**BERKELEY COUNTY PUBLIC SERVICE SEWER DISTRICT
BERKELEY COUNTY, WEST VIRGINIA**

**WASTEWATER SYSTEM IMPROVEMENTS
CONTRACT NO. 6 – RIVERSIDE WWTP CONSOLIDATION**

ADDENDUM NO. 1

SHEET No.
6

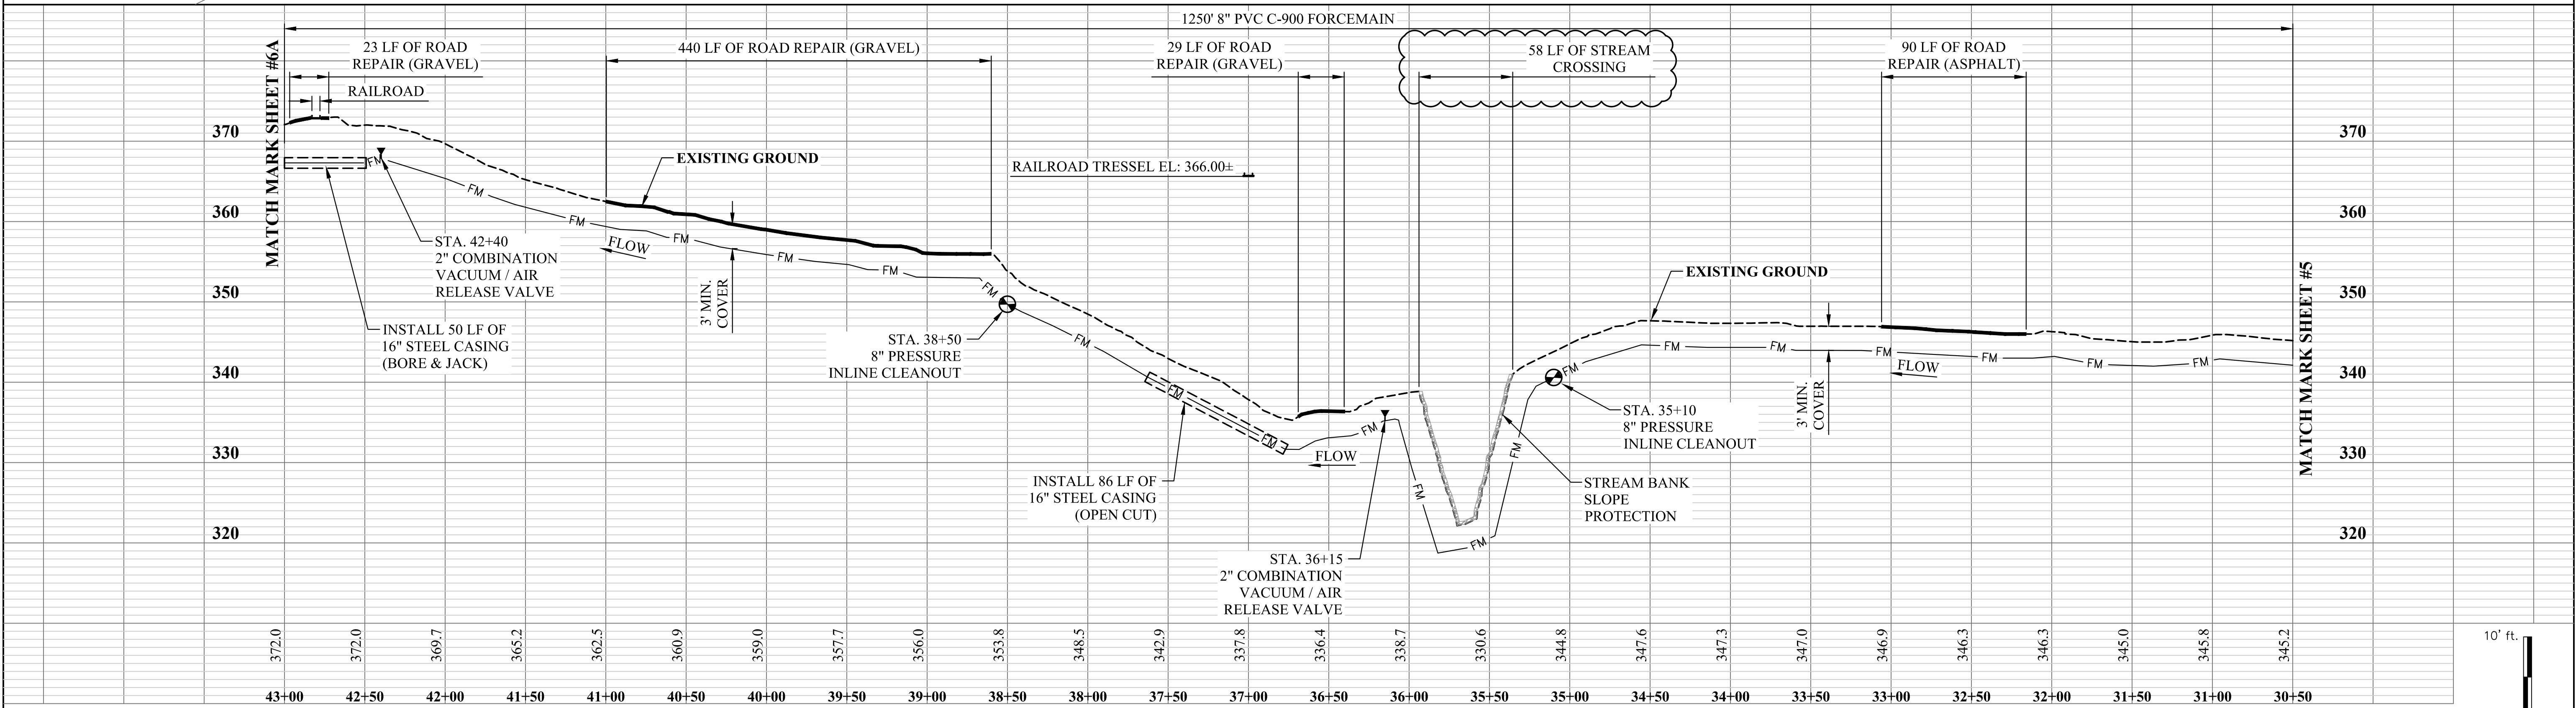
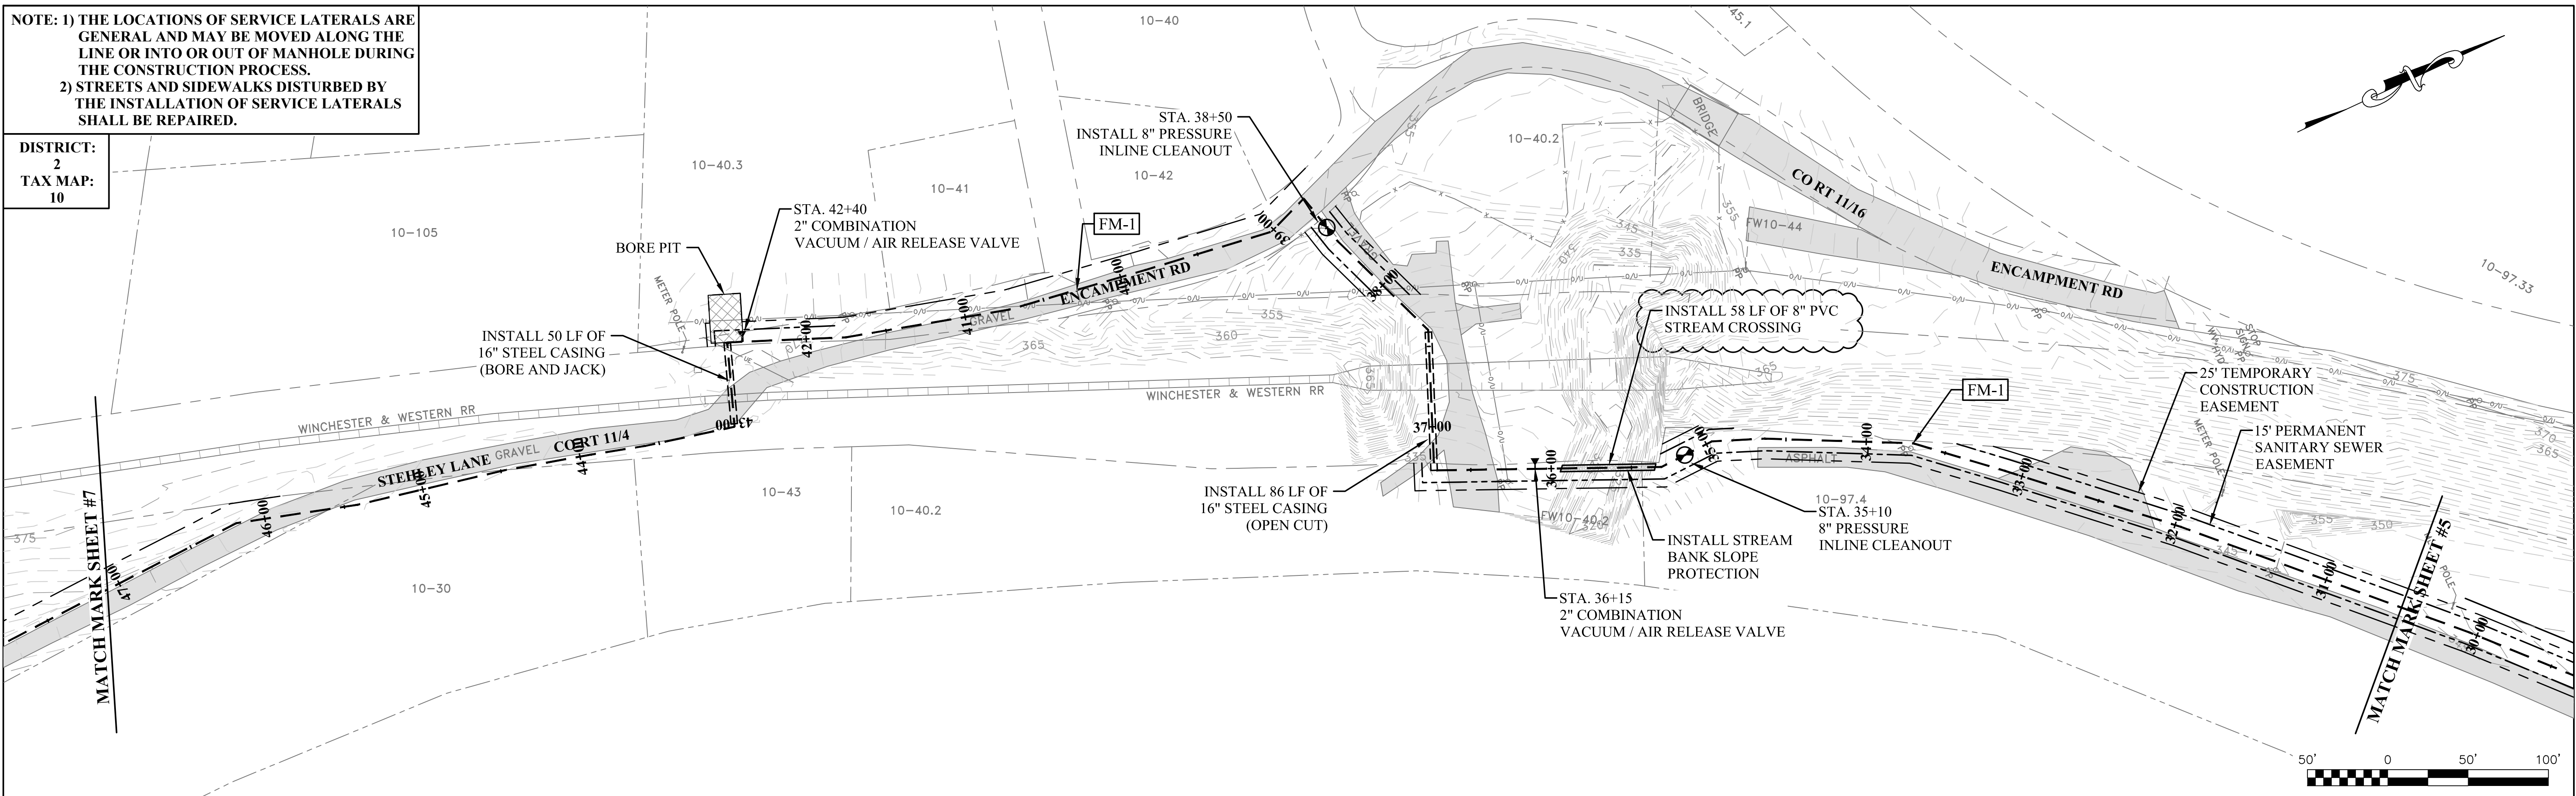
2. Sheet No. 6 – A revised sheet is included with this Addendum. A Stream Crossing was added to the plan and profile
3. Sheet Nos. 18 thru 20, Note 3 – The Owner does not have the fill material available at their Baker Heights WWTP as indicated. The Contractor must find fill material from another source.
4. Sheet No. PS-11. The pump suction piping in the wet well shall be 4" DIP in lieu of 4" SCH 80 PVC. The exterior of the DIP shall be bituminous coated.
5. Sheet No. DET-3 "Pressure In Line Cleanout" Detail. Replace detail with the enclosed "Pressure In Line Cleanout for 3" and Smaller Forcemain" (Detail 2) and "Pressure In Line Cleanout for 6" and 8" Forcemain" (Detail 3).
6. Sheet No. DET-4. The enclosed Service Lateral Detail 1 shall be used.

23. **Question:** Is there a detail for the stream crossing that is on Sheet 6 or any other streams that we encounter?
- Answer:** No. The pipe shall be installed 3'-6" below the stream bed and the stream bank protection shall consist of 6"-12" diameter rip rap with a minimum depth of 12".

NO.	BY	DATE	DESCRIPTION
1	JDE	6/6/18	ADDED STREAM CROSSING NOTE
